**STATE OF HAWAII  
DEPARTMENT OF TRANSPORTATION  
AIRPORTS**

**ADDENDUM NO. 2  
FOR  
CONCRETE SPALL REPAIRS AT TERMINAL 2 ROADWAYS  
DANIEL K. INOUE INTERNATIONAL AIRPORT  
HONOLULU, OAHU, HAWAII  
STATE PROJECT NO. AO1043-33  
AIP PROJECT NO. 3-15-0005-XXX  
MARCH 22, 2024**

**2** LIGHT POLE DETAIL - EXISTING CONDUITS EXTENDED TO NEW POLE LOCATION  
E-5000 NOT TO SCALE

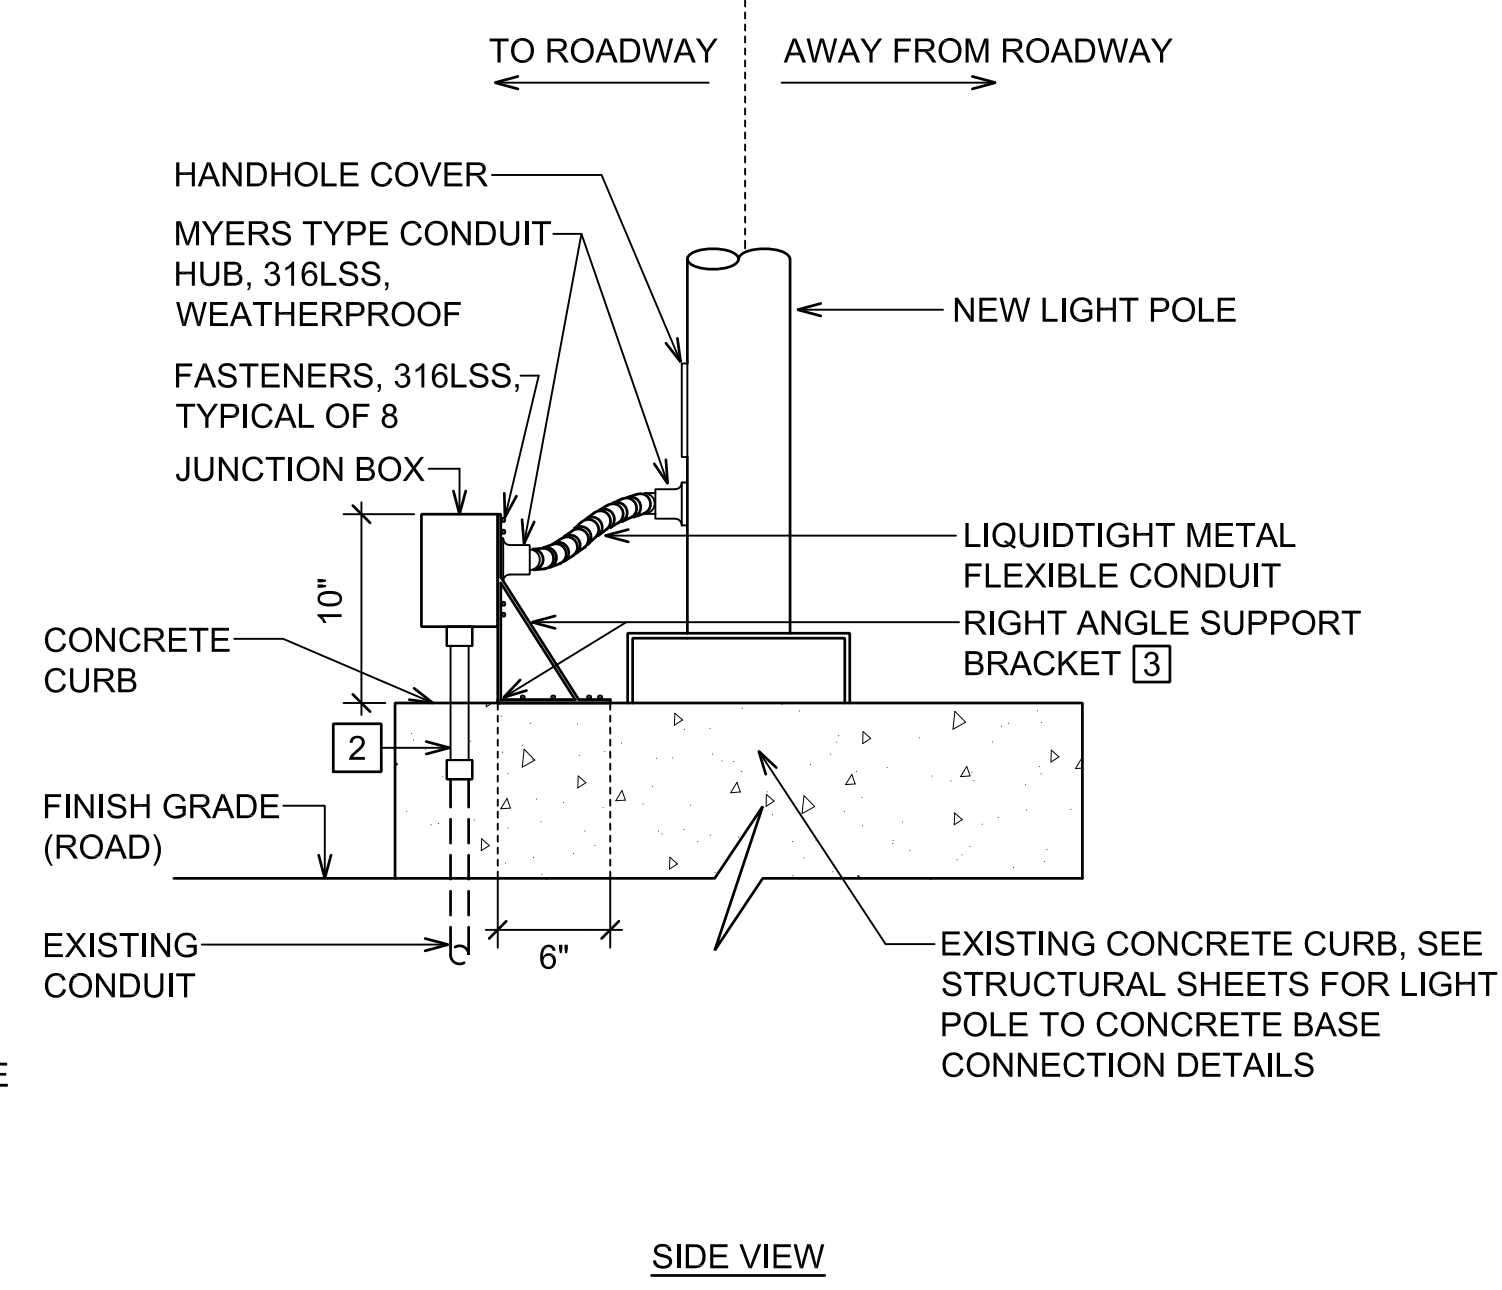
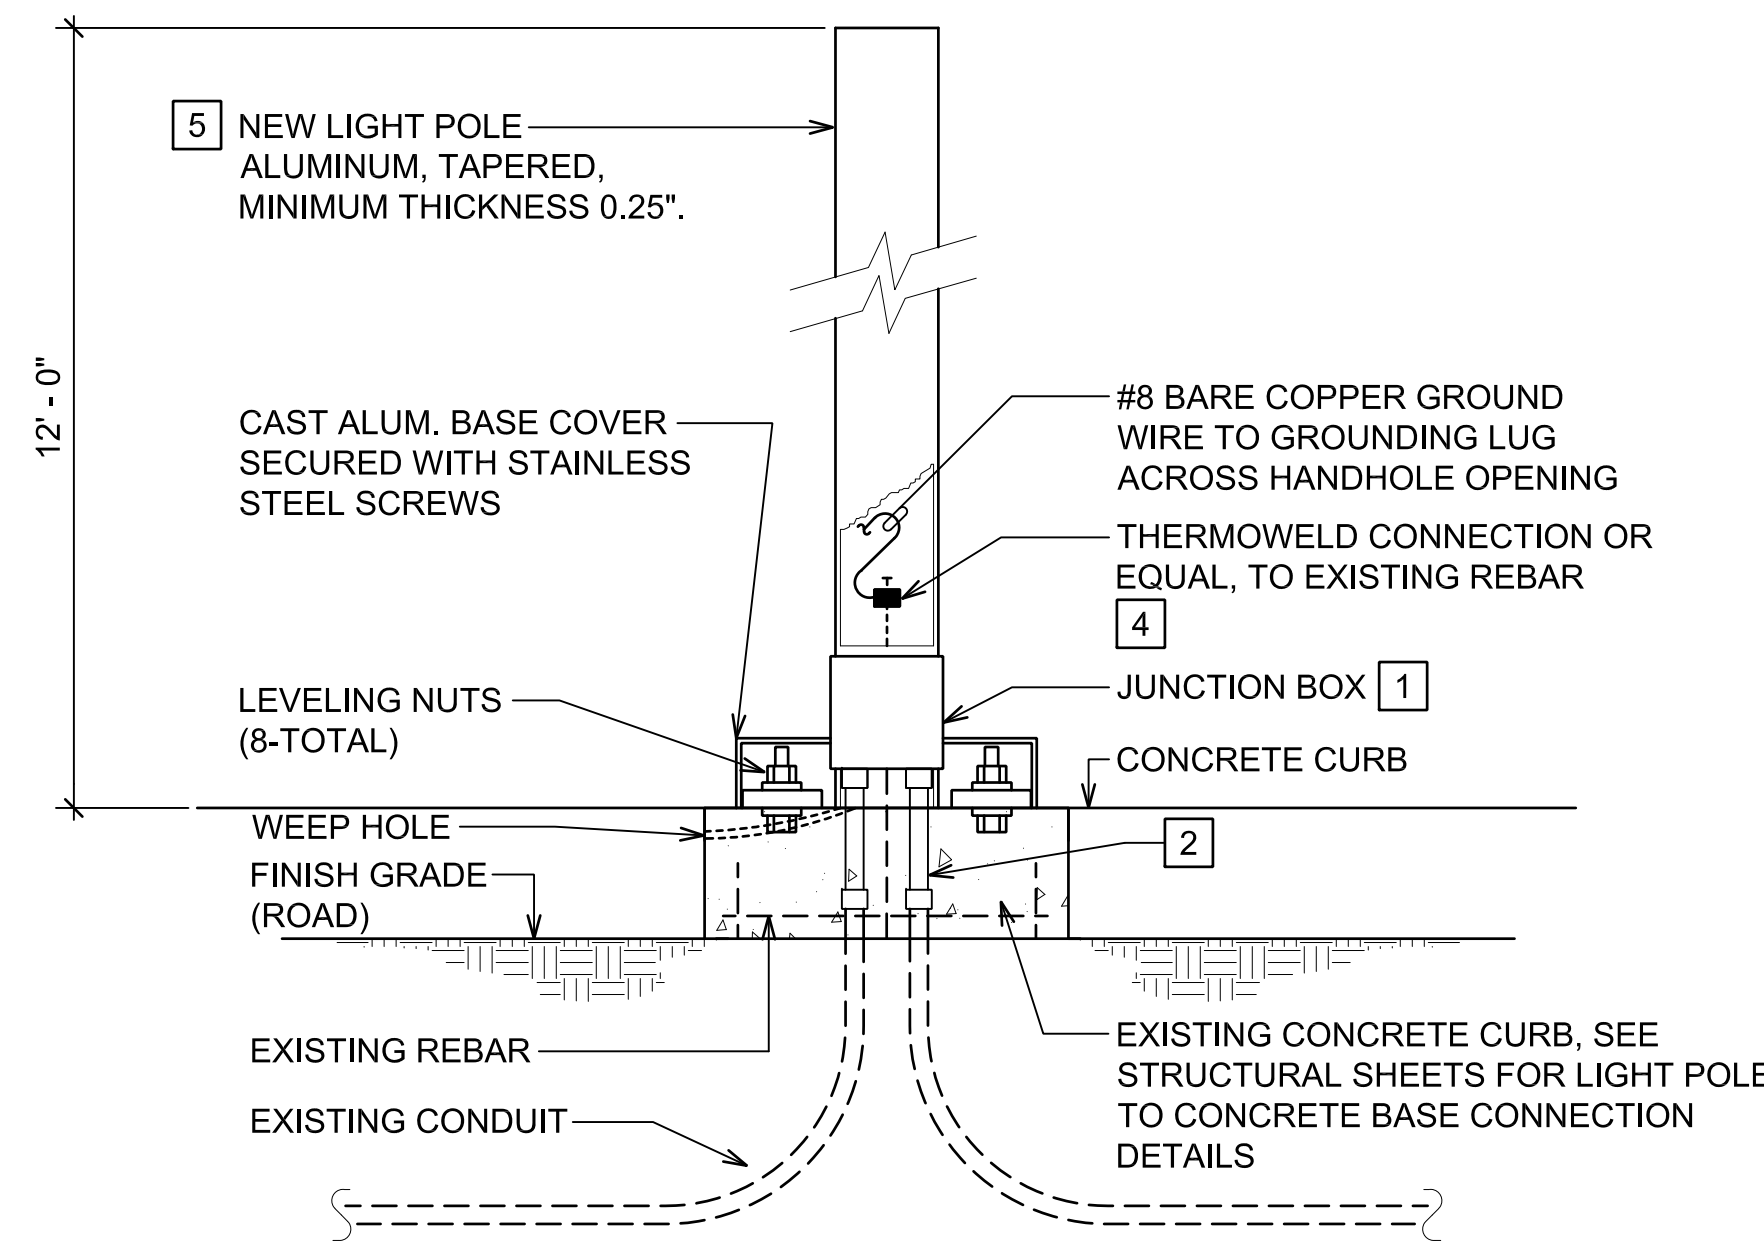
- 4 COORDINATE WITH OTHER DISCIPLINES PRIOR TO DEMOLITION TO EXPOSE EXISTING REBAR WITHIN EXISTING CONCRETE CURB.
- 5 ALUMINUM POLE, 12'-0" NOMINAL HEIGHT, ALLOY 6063-T6, CONFORMING TO ASTM B 221, MODEL VALMONT S 420040404Y4D1312 OR APPROVED EQUAL. HAPCO #SSA-12F-4-AD-SPECIFY FINISH HAS BEEN APPROVED AS A SUBSTITUTE MATERIAL FOR THE NEW LIGHT POLE. SEE ALSO GENERAL NOTES #1 & #2 ON THIS PLAN SHEET.

- HAPCO POLE SHALL BE CONSTRUCTED OF 6063-T6 ALLOY. CONTRACTOR SHALL CONFIRM FINISH TYPE WITH THE HAWAII DEPT. OF TRANSPORTATION PRIOR TO ORDERING. PROVIDE LUMINAIRE/ARM DRILLING PATTERN TO MANUFACTURER PRIOR TO ORDERING.
- NOTE THAT THE APPROVAL OF THIS MATERIAL SUBSTITUTION SHALL NOT IN ANY CIRCUMSTANCE BE CONSTRUED AS AN APPROVAL FOR DEVIATION FROM THE CONTRACT DOCUMENTS UNLESS THE ENTITY SEEKING SUCH APPROVAL HAS, IN WRITING, SPECIFICALLY CALLED THE ENGINEER'S OR THE APPROVING AGENCY'S ATTENTION TO EACH DEVIATION AT THE TIME OF SUBMISSION. SAID ENTITY AND/OR AFFECTED MATERIALS, EQUIPMENT, AND LABOR TO ENSURE PROPER EXECUTION OF THE WORK AS PER THE INTENT OF THE CONTRACT DOCUMENTS.

**1 LIGHT FIXTURE SCHEDULE**  
E-5001 NOT TO SCALE

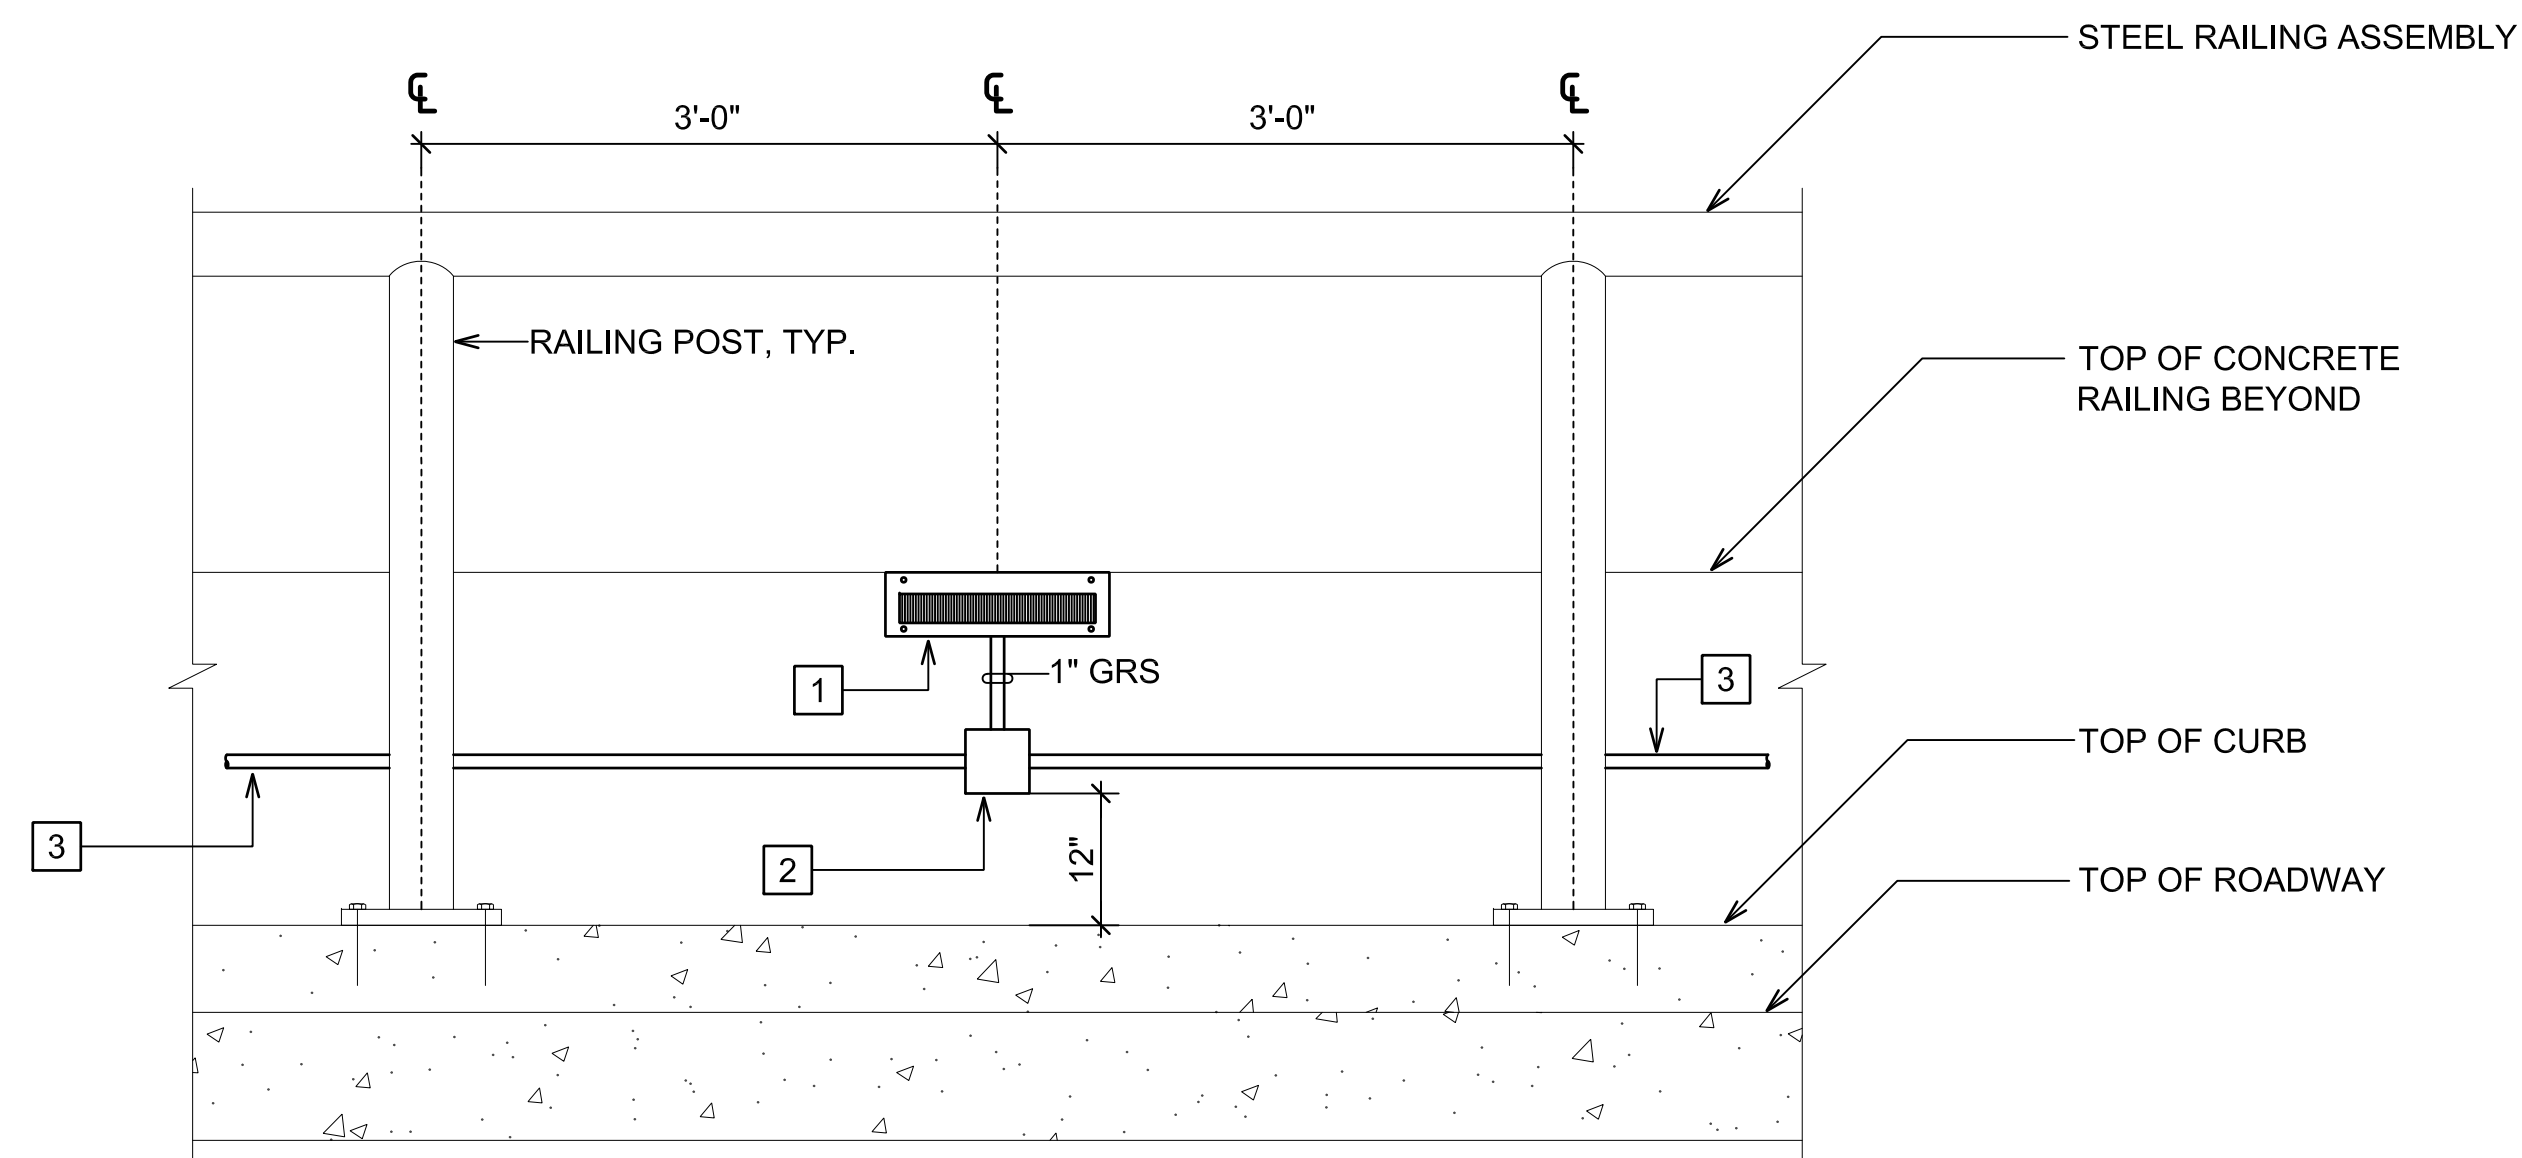
- KIM LIGHTING #UR20-56L75-4K8-4-UNV-ASQ-BLT-7PR-TL-CLR (80 CRI MINIMUM) HAS BEEN APPROVED AS A SUBSTITUTE MATERIAL FOR THE ARM MOUNT.
- NOTE THAT THE APPROVAL OF THIS MATERIAL SUBSTITUTION SHALL NOT IN ANY CIRCUMSTANCE BE CONSTRUED AS AN APPROVAL FOR DEVIATION FROM THE CONTRACT DOCUMENTS UNLESS THE ENTITY SEEKING SUCH APPROVAL HAS, IN WRITING, SPECIFICALLY CALLED THE ENGINEER'S OR THE APPROVING AGENCY'S ATTENTION TO EACH DEVIATION AT THE TIME OF SUBMISSION. SAID ENTITY AND/OR AFFECTED MATERIALS, EQUIPMENT, AND LABOR TO ENSURE PROPER EXECUTION OF THE WORK AS PER THE INTENT OF THE CONTRACT DOCUMENTS.
